- **FUEL SYSTEM—EFI ENGINES—AIR BY-PASS VALVE REPLACEMENT PART INOPERATIVE**
- **IDLE—ROUGH—REPLACEMENT AIR BY-PASS VALVE INOPERATIVE**

**Article No.
89-24-4**

Figure 1 - Article 89-24-4

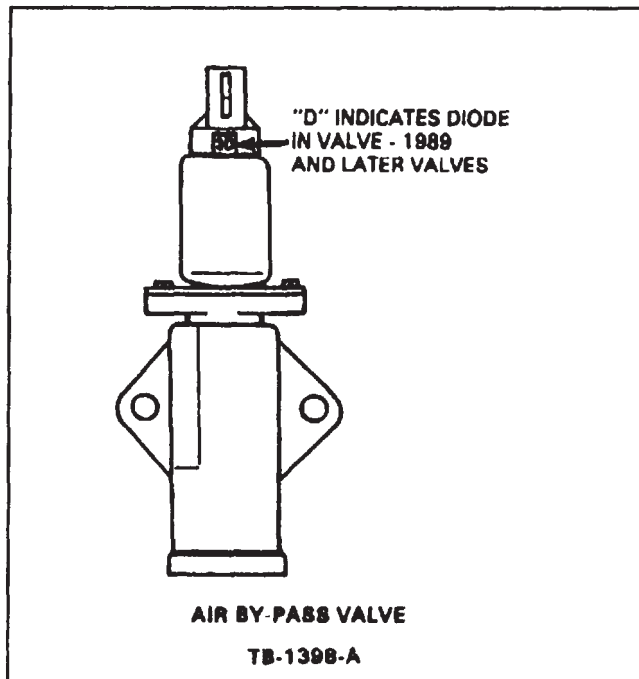
Vehicles built before the 1989 model year had a diode in the air by-pass valve wiring harness. The new replacement valves have a 3D marking on the plastic portion of the solenoid, above the connector cap, Figure 1. They have a diode in the air by-pass valve.

On the air by-pass valves used on vehicles built before the 1989 model year, the positive and negative leads are not important to the operation of the valve. However, the polarity on the new replacement air by-pass valve is important because if the wiring harness is reversed the air by-pass valve will not work.

ACTION: Reverse the wires in the air by-pass valve connector and retest the valve. Refer to the following EFI Engine Application Chart for engines using these air by-pass valves.
